# STAFF RECOMMENDATION

NCPC File No. 6690

## RESERVATION 174: NORTHWEST PARK (OLD CONVENTION CENTER SITE)

March 27, 2008

### MOUNT VERNON SQUARE WITH BOW-TIE RESERVATIONS

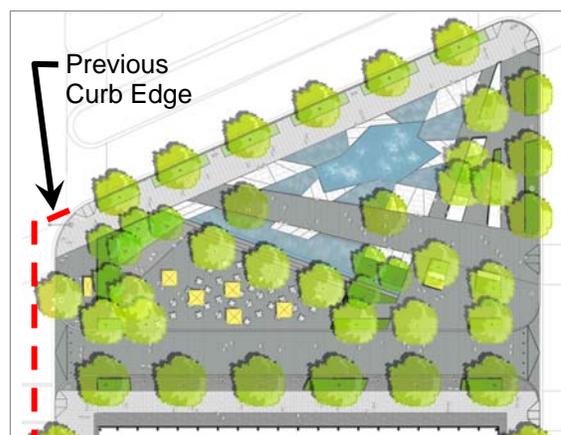
The project site is one-half of a pair of “bow-tie” reservations, and one of four pairs that surround historic Mount Vernon Square. These reservations comprehensively serve to connect the surrounding neighborhoods with the Square as well as to anchor the Square into the larger context of the L’Enfant plan for the city. Collectively, Reservations 173 and 174 also serve to frame and enhance the views east toward the Square and west toward the White House.

Staff supports the overall site development plans and commends the development team on a high-quality, durable, and sustainable design that respects the historic L’Enfant streets and reservations of the District of Columbia. Staff also supports the re-establishment and general design of those portions of 10<sup>th</sup> and I Streets adjacent to the Reservation, and notes that the 1965 Baist map should provide the basis for locating street, sidewalk, and curb lines.
